Addendum Number 2

DISPLAY STATION (DIRECT VIEW LED DISPLAY SYSTEM)

Bid # 10361

Global Innovation and Welcome Center Screen Bid Questions and Request for Information

SIGN 3 - INTERIOR
LED SCREEN INDICATED BY RED REGION

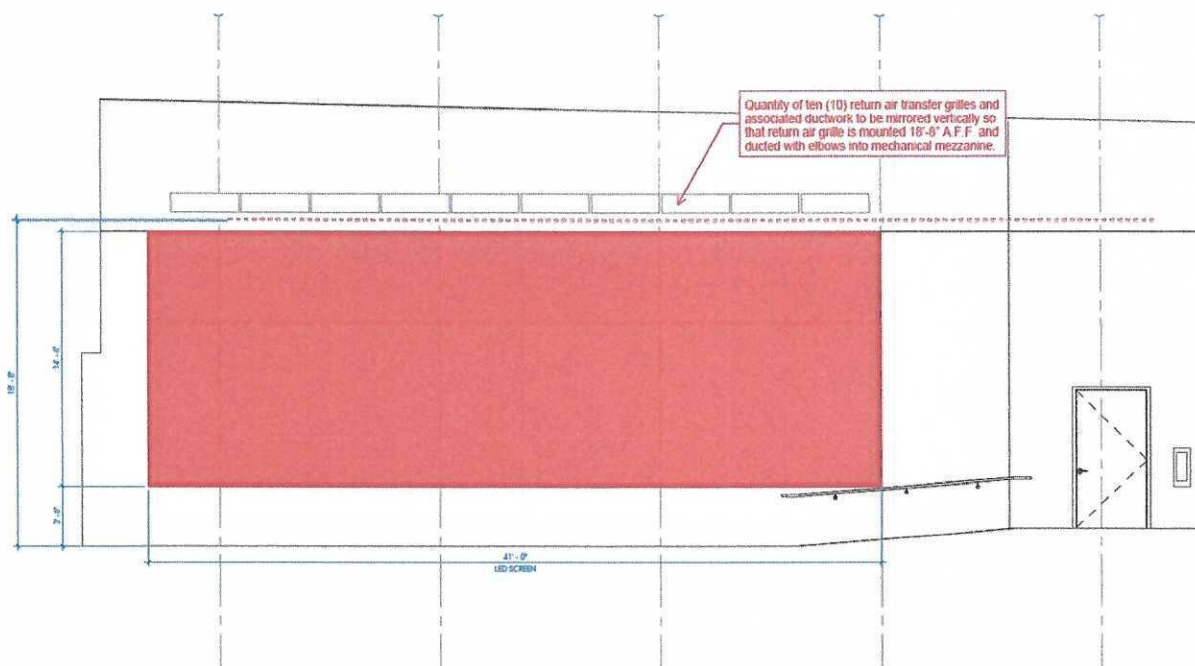
41'-0" width but no height. What is the required height, and what tolerance applies to the overall dimensions?

Can you provide a drawing of the room?

What is the Total LED wall dimension you require?

The minimum height requirement is 14'-6". A tolerance of $\pm 1'$ is acceptable for the height and width of the video wall.

The floorplan and wall sketch are attached above. The room construction drawings can be found at https://www.icloud.com/iclouddrive/04aC1kJAaDnR_A6y1fgtdvHkw

Approximate 14'6" x 41'-0" (see attached sketch)
